COI-1 Structural Engineering Expert Report

MTRCL Shatin to Central Link Contract 1112

10 December 2019

Figure 1 – Illustration of the coupler connection at the EWL slab side and capping beam / diaphragm wall side

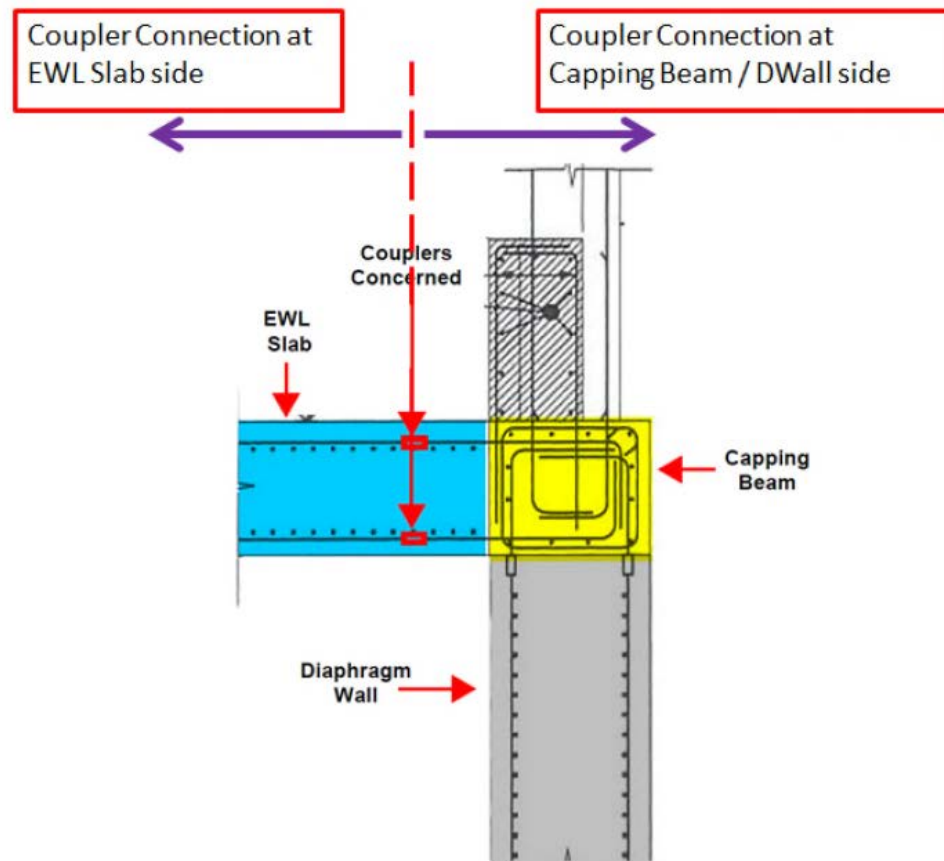
54. Because of the defective coupler connections, a large amount of design calculations was carried out by MTRCL's consultants, namely Atkins, Arup and AECOM. The consultants carried out an assessment based on the Updated Design of the structure and found that because of reserve capacities, no suitable measures were needed in many areas. The Stage 3 Assessment Report, however, indicated that there were locations on the structure where the strength utilization ratios were greater than unity, meaning that these locations would be overstressed under one or more of the design loading conditions [OU6/4496, 9308]. This was the reason why suitable measures were proposed at these locations. The suitable measures were needed to increase the structural capacity of the structure at these locations so as to lower the utilization ratio down to below 1.

Figure 3 - Typical section of joint showing the main longitudinal rebar

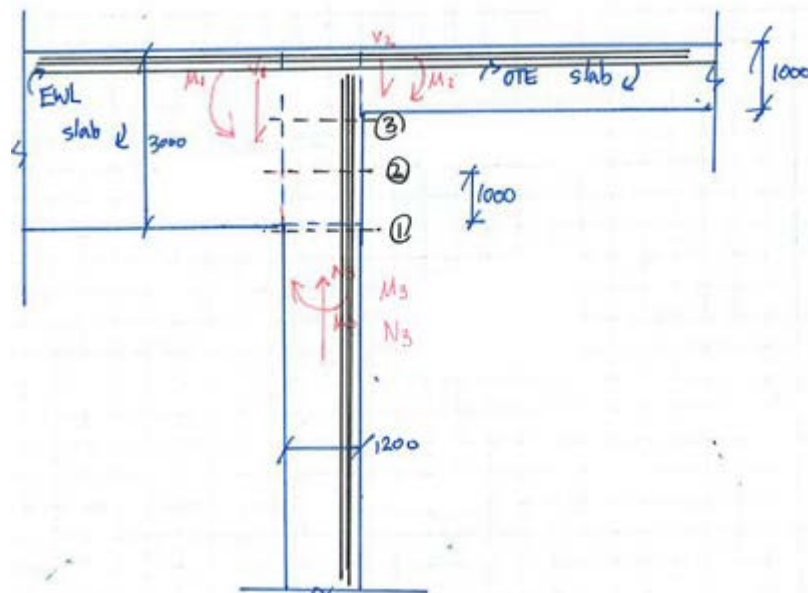
141. It is not desirable to rely on concrete to take tensile force because concrete is weak in tension. The other way was to allow the forces to be transferred by

142. Based on the assumptions of the Original Design, the analyses showed that the joint was overstressed. Under the revised design assumptions of the Updated Design, the results of the simplified hand calculations and finite element analyses by the consultants showed that the joint was no longer overstressed **[OU6/4107-4110]**.
